2.0 SITE CHARACTERISTICS

This chapter of the Fermi 3 Combined Operating License (COL) Final Safety Analysis Report (FSAR) addresses the geological, seismological, hydrological, and meteorological characteristics of the site and vicinity, in conjunction with present and projected population distribution and land use, and site activities and controls.

Section 2.0 of the Fermi 3 COL FSAR, Revision 7, incorporates by reference Section 2.0 of the ESBWR DCD, Revision 10. In addition, the applicant provides the following:

Figure 2.5.2-12 Comparisons of the Staff's Site Response Amplification Functions with the Amplification Functions Determined by the Applicant

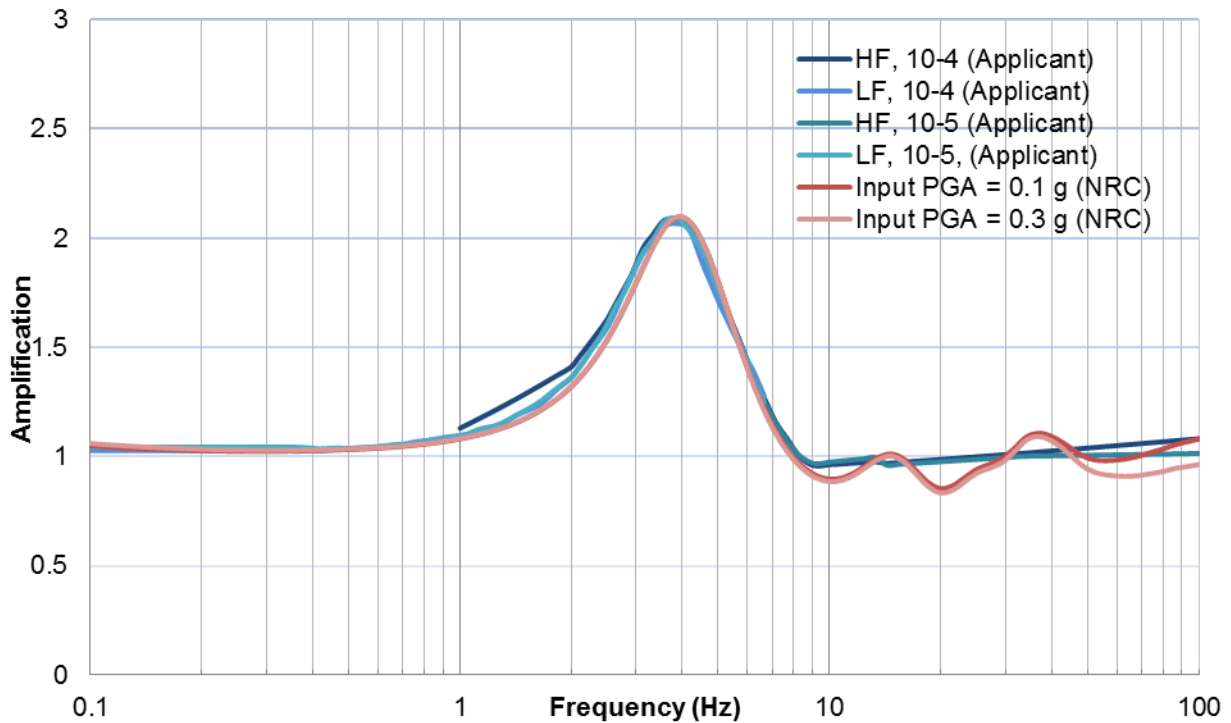
As Figure 2.5.2-12 in this SER shows, the applicant's amplification functions are similar to the staff's confirmatory calculations; and the very small difference observed between ~1 and 100 Hz are within the limits of uncertainties. Similar to the applicant's results, the staff's confirmatory calculations also show that the Fermi 3 site response is not strongly sensitive to the level of input motion. Figure 2.5.2-12 also shows that there are only small differences in the site amplification (at frequencies greater than ~40 Hz) using input PGAs of 0.1 g and 0.3 g.

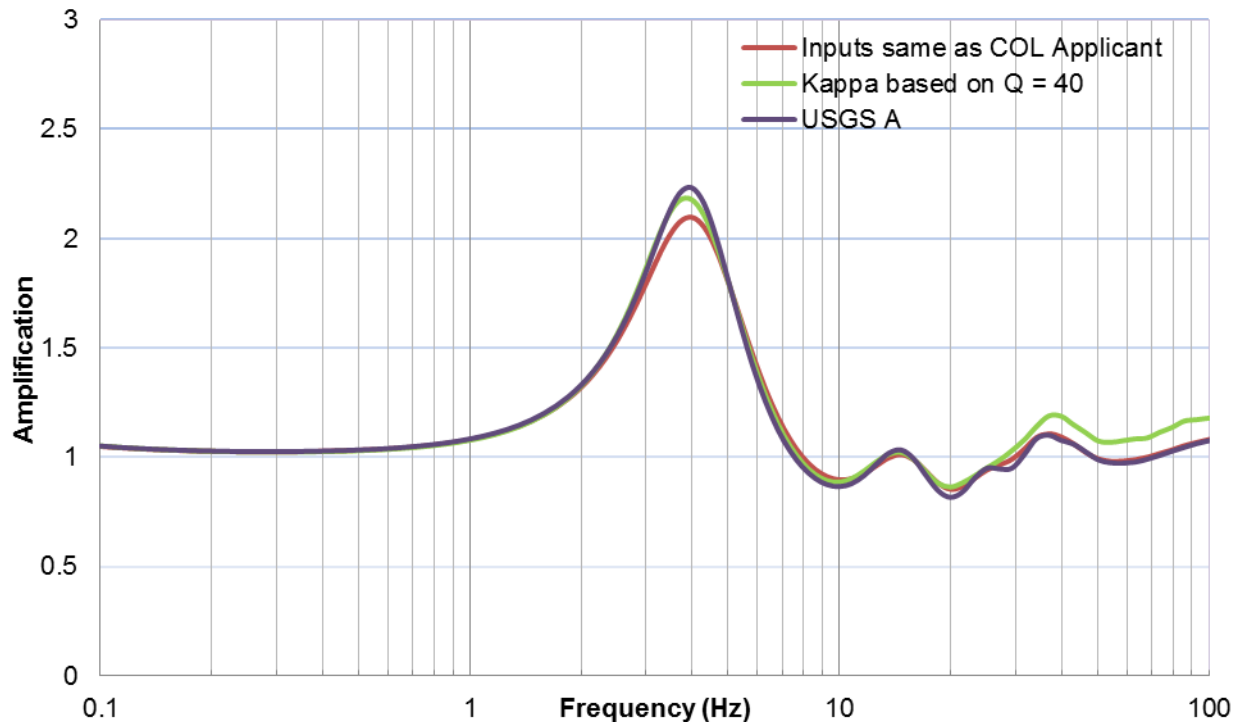
In addition to confirming the applicant's calculations, the staff conducted an additional sensitivity calculation to confirm the applicant's selected damping values in FSAR Table 2.5.2-214. Figure 2.5.2-13 in this SER compares the staff's amplification functions calculated using the applicant's damping values, with the staff's amplification functions calculated assuming a shear-wave quality factor, Q_s , of 40. Because the average S-wave velocity of the material above an elevation of 48 m (156 ft) is 1,737 m/s (5,700 fps), and the thickness of these materials is only ~121 m (396 ft), the kappa contributed by the profile can be computed by assuming a Q_s of 40 according to EPRI Report 1025287, "Seismic Evaluation Guidance," (EPRI 2012). As illustrated in Figure 2.5.2-13 of this SER, the staff's amplification functions calculated by assuming a Q_s of 40 is only slightly higher than the staff's calculated amplification functions that used the damping values developed by the applicant between frequencies of ~3 to 5 Hz and at frequencies above 30 Hz.
